***MELGES<sup>20</sup>***

FIND BELOW SAMPLES OF ILLEGAL USE OF EQUIPMENT

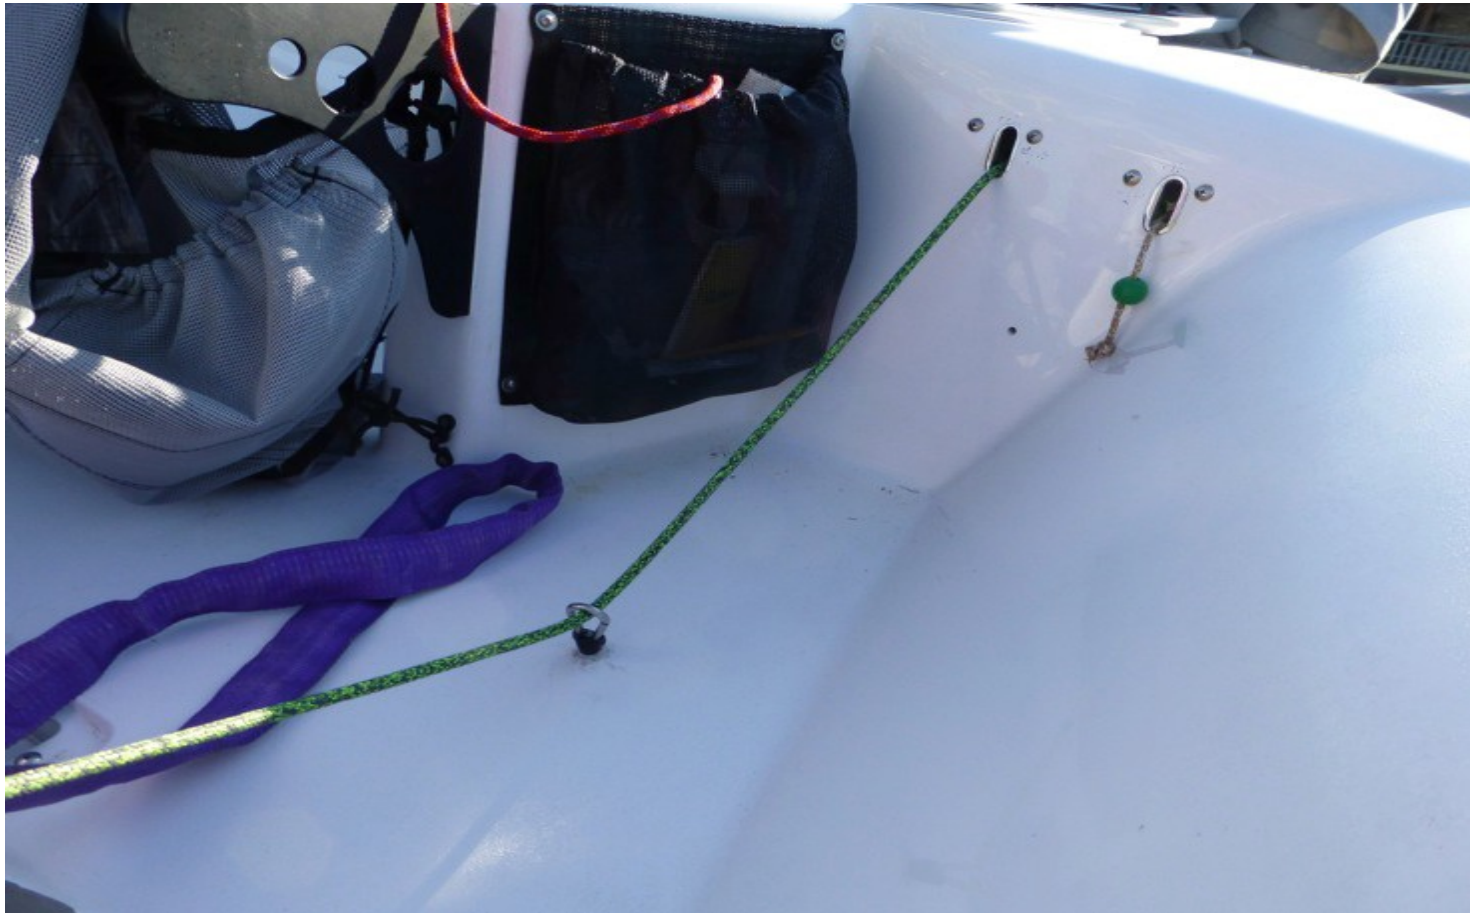
Class rule C-6-1(b): The method of attaching any fitting to the boat is unrestricted but shall not modify the fittings position, the effective operation of the fitting nor the intended purpose or action of any equipment and provided their fixing gives no performance advantage

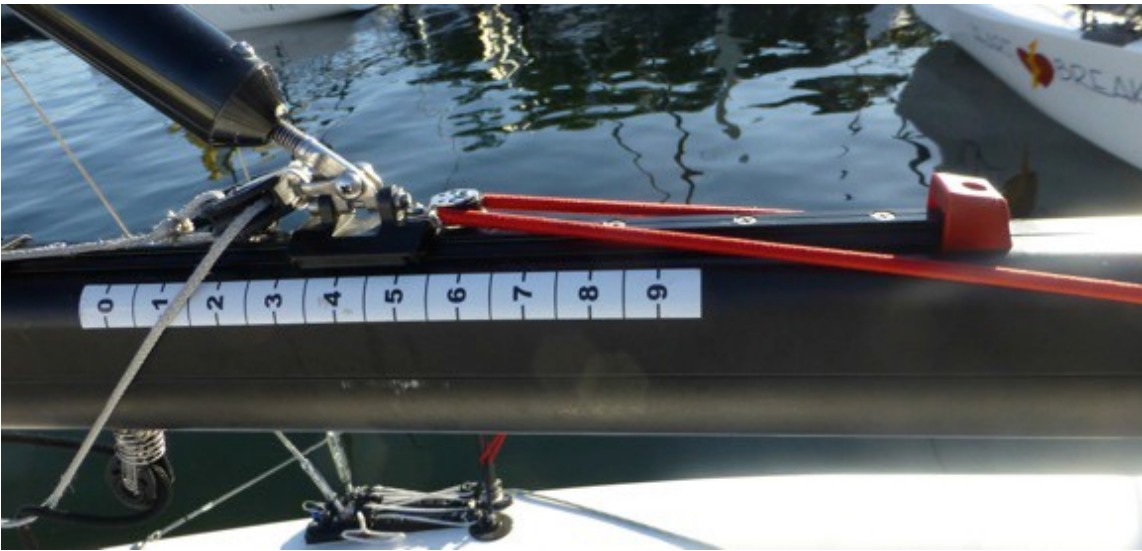
CLASS RULE C.6.1.(a): The use of Velcro, shockcord, Teflon tape, flexible adhesive tape, rope, stainless rings, pulleys, shackles is unrestricted as long as this does not modify the sheeting angle of any sail when loaded .....  
The shockcord on the vang is illegal.

This additional Yellow line is ILLEGAL, because its use can modify the sheeting angle of the mainsail
